# **M3 Junction 9 Improvement**

**Scheme Number: TR010055**

## **8.5 Applicant Response to Examining Authority's First Written Questions (ExQ1)**

**15 June 2023**

Figure 1.1: RSA problem 2.2.1 and 2.6.4 (extract from Appendix C of the Applicant Response to the Examining Authority's First Written Questions (Document Reference 8.5))

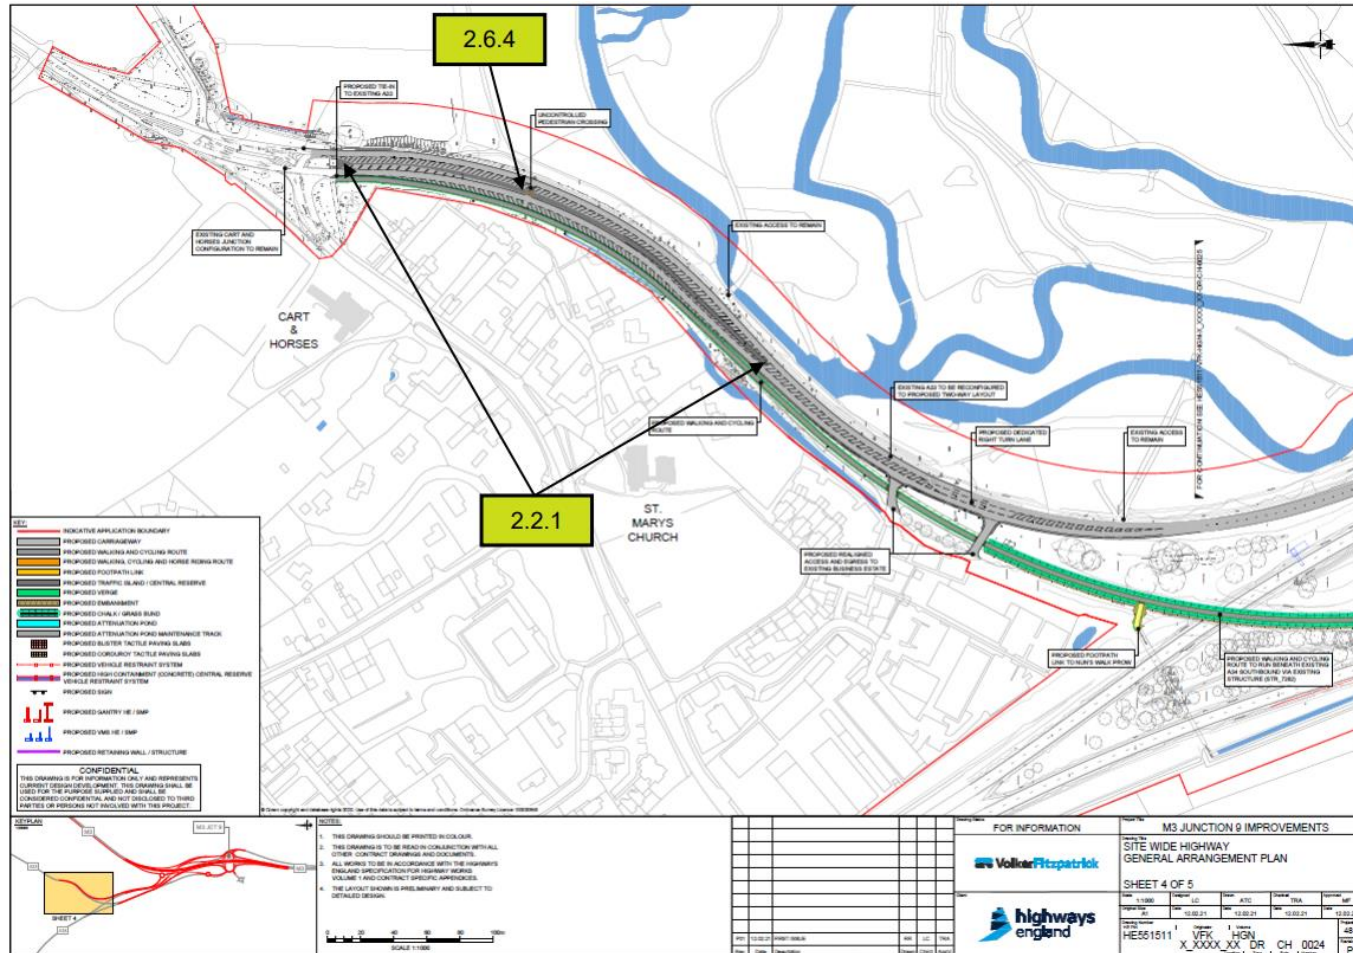
2.6.4 (see <b>Figure 1.1</b> )	<p><b>Location</b>            A33 Link Road; uncontrolled pedestrian crossing point near northern tie-in</p> <p><b>Summary:</b>            Risk of pedestrians being struck by vehicles as they cross wide carriageway            Pedestrians could be vulnerable crossing the wide carriageway, where speeds could be high. In particular, if pedestrians wait on the crosshatch road markings, they will have a false sense of security and could be struck by vehicles that veer into this area.</p>	The crossing point should be, made safer by incorporating, buildouts into the hatched, areas to reduce the crossing, distance. (See also Problem 2.2.1).	<p><b>Recommendation: Accepted</b>            This recommendation will be incorporated within the current proposed works going forwards.</p>	Design Organization's response is accepted and agreed.	In line with the RSA recommendation.

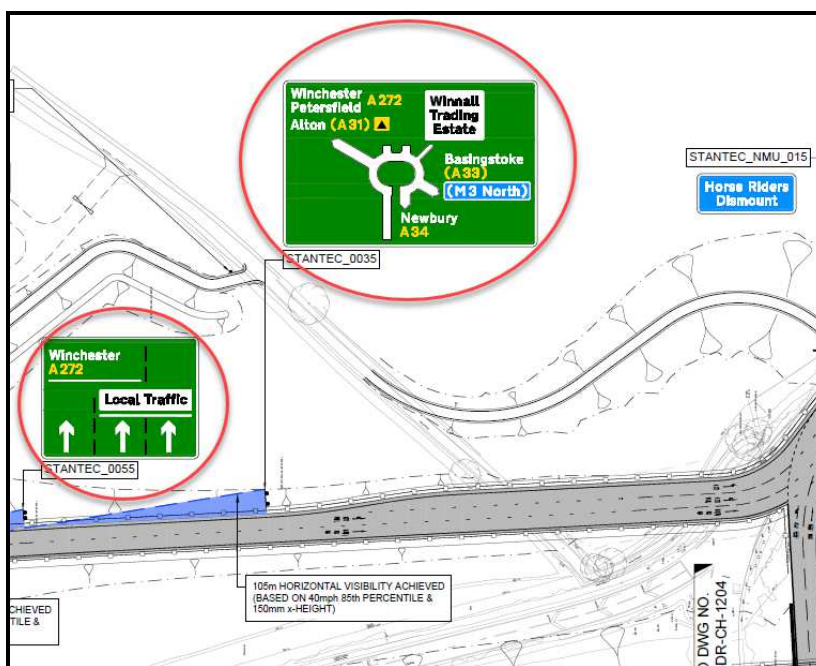
It was not possible to accurately measure the entry path curvature (EPC) at the entry to the gyratory. However, the EPC could be too high due to the large entry radius. A high EPC value could lead to vehicles entering the gyratory at high speed and colliding with circulating vehicles.

The EPC at the entry should be checked and geometric amendments made if necessary to ensure the value does not exceed 100m.
